UNITED STATES PATENT AND TRADEMARK OFFICE

10/743,854

Office Action Summary	Application No.	Applicant(s)	
	10/743,854	MATSUSHITA ET AL.	
	Examiner	Art Unit	
	Burton S. Mullins	2834

DETAILED ACTION

Fig. 2.

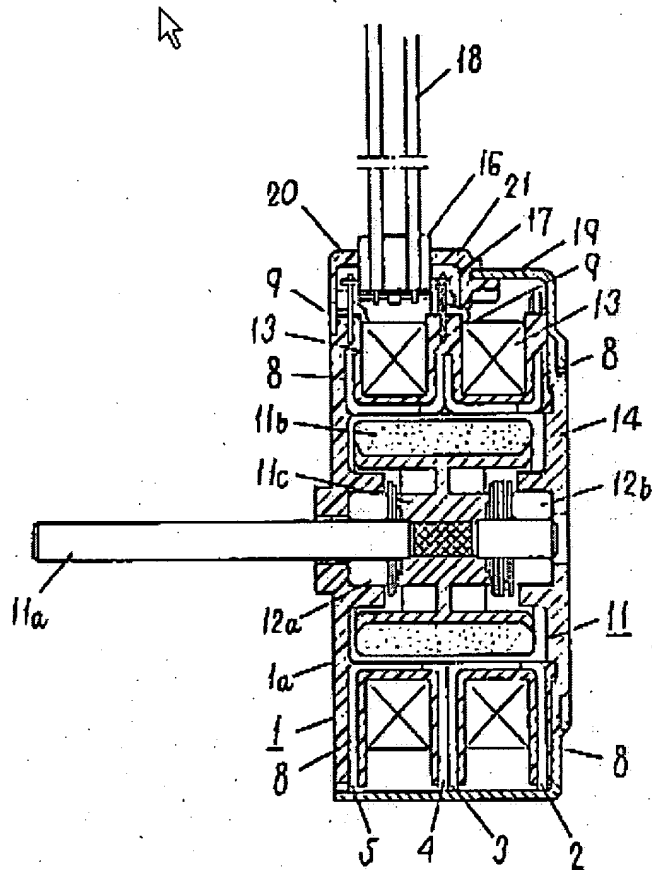
5. Claims 2, 7 and 11-12 are rejected under 35 U.S.C. 103(a) as being unpatentable over Akiba et al. (US 4,714,850) in view of Tanaka (US 4,015,154), further in view of Horberg (US 3,001,839). With reference to the marked Figure 2 below, Akiba teaches a stepping motor comprising: a rotor 11 including a shaft 11a and a magnet 11b surrounding a portion of the shaft (Fig.2); a stator 1 surrounding the magnet of the rotor with a gap therebetween (not numbered, Fig.2), and adapted to generate a magnetic field thereby causing the rotor to rotate around an axis of the shaft (inherent); a rotor sleeve 11c having a cylindrical portion (not numbered, Fig.2) and a flange (not numbered, Fig.2) provided at one end of the cylindrical portion, the rotor sleeve 11c being provided between the magnet 11b and the shaft 11a so as to fixedly hold the magnet and the shaft together (Fig.2); a boss (holding part) 1a having a circular shape with a center hole (not numbered; Fig.2) for allowing the shaft 11a to rotatably pass therethrough and being formed (by monolithic resin molding) with the stator 1 (c.3, lines 37-51) so as to oppose the flange of the rotor sleeve (Fig.2); and a bearing 12a rotatably disposed between the boss and flange of the rotor sleeve (Fig.2).

Akiba does not teach: 1) ball bearings, per se, for the bearing 12a; or 2) an inner surface of the boss beveled to form a conical configuration with a diameter increasing from the center hole of the boss.⁷

It would have been obvious to modify Akiba and provide ball bearings per Tanaka as the bearings of since the ball bearings would have been desirable to support the rotor shaft; and further to provide a conical surface on the boss per Horberg so as to facilitate bearing pre-loading.
